SIM 34 02 24

RECALL 24V-697: INTEGRATED BRAKE SERVOMOTOR

This Service Information Bulletin (Revision 7) replaces SI M34 02 24 **dated May 2025**.

- Correction updated with new part number
- Parts Information updated

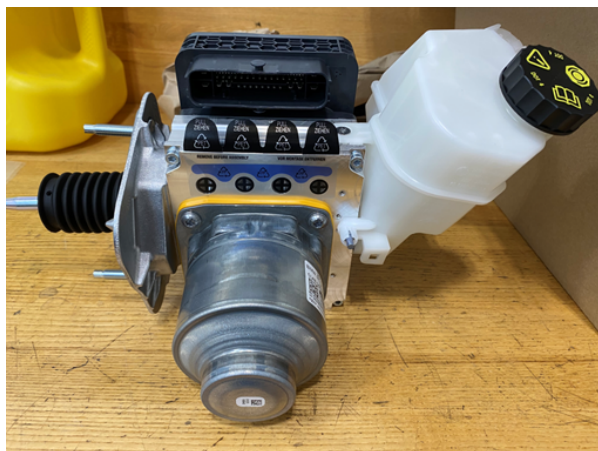
Replace the IB with either a “wet” pre-filled unit or a “dry” unfilled unit.

“**Wet**” IB pre-filled: Brake fluid reservoir is filled (arrow) and the four brake fluid line ports are plugged with bolts (circled).

“**Dry**” IB unfilled: Brake fluid reservoir is empty, and the brake fluid line ports are sealed with labels.

Part number:
5B67B85
5B72715
5B72716
5B6A736

Part number:
5B3C874
5B6C7F1

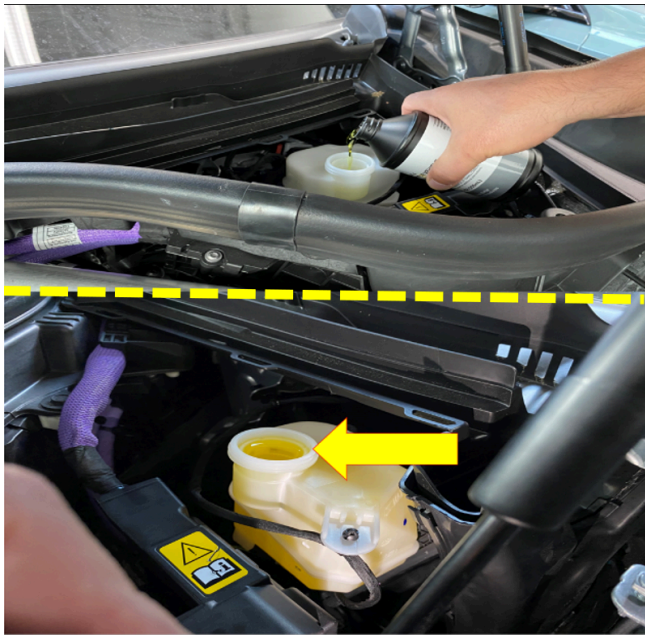
Do not install any part which shows visual damage as shown, or has been dropped from any height.

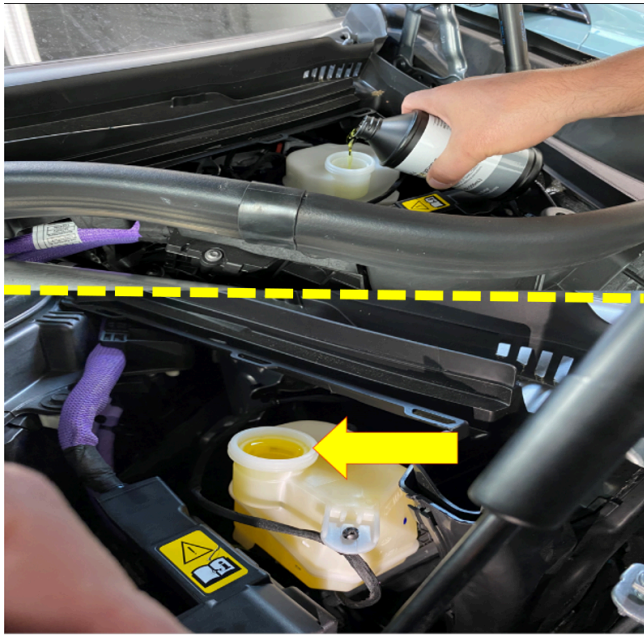
- Prior to installation, the Integrated Brake Modules should be inspected for damage upon arrival. Light scratches are acceptable; but if the aluminum cover is dented or bent, please send photos in a Recall IDS Ticket for review prior to entering a claim. If approved, please claim in accordance with the Dealer Services Return and Claims Manual.

Do not install any part which shows visual damage as shown, or has been dropped from any height.
